Irisys People Counters Technical Bulletin

4th December 2012.

Issue: **01**

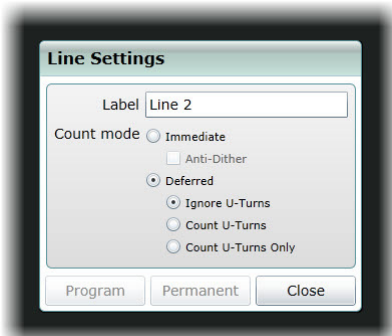
We've had a few enquiries about why the 'Count Mode' selection in the 'Advanced' settings dialog is now greyed out when configuring counters running the very latest firmware, see left.

Why have we done this? Well, it's because every count line can now have its own distinct count mode!

In a slight change, the default count mode is now 'Deferred' with 'Ignore U-Turns', instead of the previous 'Deferred' with 'Count U-Turns'.

This is now fully explained in the latest software guide (available from the partner portal, see above), but to enable everyone to get going quickly, you must now right click on the individual count line and go into 'Settings' in order to access the count mode. You can also set the line label here too.
